**TSG-RAN Meeting #12
Stockholm, Sweden, 12 - 15 June 2001**

RP-010313

Title: Agreed CRs (Release '99 and Rel-4 category A) to TS 25.331 (3)

Source: TSG-RAN WG2

Figure 60: Examples for frame allocations in TDD

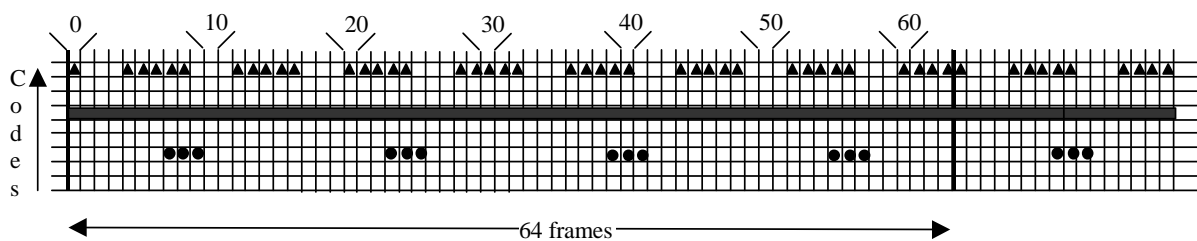
Title:	⌘ Clarification on multiframe allocation in TDD		
Source:	⌘ TSG-RAN WG2		
Work item code:	⌘ TEI	Date:	⌘ 3.05.2001
Category:	⌘ F	Release:	⌘ R99
<p>Use <u>one</u> of the following categories:</p> <p>F (correction) A (corresponds to a correction in an earlier release) B (Addition of feature), C (Functional modification of feature) D (Editorial modification)</p> <p>Detailed explanations of the above categories can be found in 3GPP TR 21.900.</p>		<p>Use <u>one</u> of the following releases:</p> <p>2 (GSM Phase 2) R96 (Release 1996) R97 (Release 1997) R98 (Release 1998) R99 (Release 1999) REL-4 (Release 4) REL-5 (Release 5)</p>

Reason for change: ⌘	<p>The signalling allows to define multiframe allocations that are not compatible with each others. Therefore there is a need to clarify the requested behaviour of the UEs.</p> <p>The added descriptions are consistent with the examples that are provided in WG1 specifications for common channels.</p> <p>The UE requirements in terms of reception of physical channels are not totally clearly described.</p> <p>In order to reduce the requirements of the UEs UEs are not required to receive the FACH channel while receiving DSCH. Thus simultaneous reception of these two channels is not required but the UE shall switch between the channels depending on whether a PDSCH is allocated to the UE or not.</p> <p>Clarification on SCCPCH reception requirements for shared channel operation in TDD.</p> <p>Backward compatibility aspects:</p> <ul style="list-style-type: none"> • Reception of common physical channels Colliding configurations are possible. Therefore the precedence of the physical channels needs to be specified to ease terminals life. UEs implementing previous versions of the standard would not have the knowledge. It is expected that most implementations would have used this implementation because it conforms to the examples given in 25.221. • Reception of FACH while DSCH is allocated Without this CR UEs would have to monitor also while a DSCH is allocated. This would not cause any problems but Ues would receive the FACH without being required to. • Reception of SCCPCH in shared channel operation in TDD Clarifies common understanding.

If no IE "Offset" is explicitly given, the parameter "Offset" to be used is calculated by the following equation:

$$\text{Activation time mod Repetition period} = \text{Offset.}$$

Frames from CFN CFN_{off} to $CFN_{\text{off}} + \text{Repetition length}$ belong to the allocation with CFN_{off} fulfilling the following equation:

$$CFN_{\text{off}} \text{ mod Repetition period} = \text{Offset.}$$

Figure 60: Examples for frame allocations in TDD

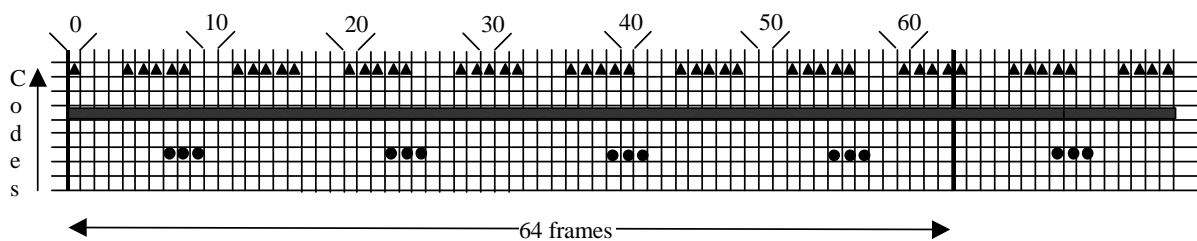
Title:	⌘ Clarification on multiframe allocation in TDD		
Source:	⌘ TSG-RAN WG2		
Work item code:	⌘ TEI	Date:	⌘ 23.05.2001
Category:	⌘ A	Release:	⌘ REL-4
	Use <u>one</u> of the following categories: F (correction) A (corresponds to a correction in an earlier release) B (Addition of feature), C (Functional modification of feature) D (Editorial modification) Detailed explanations of the above categories can be found in 3GPP TR 21.900.		Use <u>one</u> of the following releases: 2 (GSM Phase 2) R96 (Release 1996) R97 (Release 1997) R98 (Release 1998) R99 (Release 1999) REL-4 (Release 4) REL-5 (Release 5)

Reason for change:	⌘ The signalling allows to define multiframe allocations that are not compatible with each others. Therefore there is a need to clarify the requested behaviour of the UEs. The added descriptions are consistent with the examples that are provided in WG1 specifications for common channels. The UE requirements in terms of reception of physical channels are not totally clearly described. In order to reduce the requirements of the UEs UEs are not required to receive the FACH channel while receiving DSCH. Thus simultaneous reception of these two channels is not required but the UE shall switch between the channels depending on whether a PDSCH is allocated to the UE or not. Clarification on SCCPCH reception requirements for shared channel operation in TDD.
Summary of change:	⌘ Clarification on requirements of physical channel reception are included.
Consequences if not approved:	⌘ Interpretation of multiframe allocations unclear. Unnecessary requirements on the UE

If no IE "Offset" is explicitly given, the parameter "Offset" to be used is calculated by the following equation:

$$\text{Activation time mod Repetition period} = \text{Offset.}$$

Frames from CFN CFN_{off} to $CFN_{\text{off}} + \text{Repetition length}$ belong to the allocation with CFN_{off} fulfilling the following equation:

$$CFN_{\text{off}} \text{ mod Repetition period} = \text{Offset.}$$
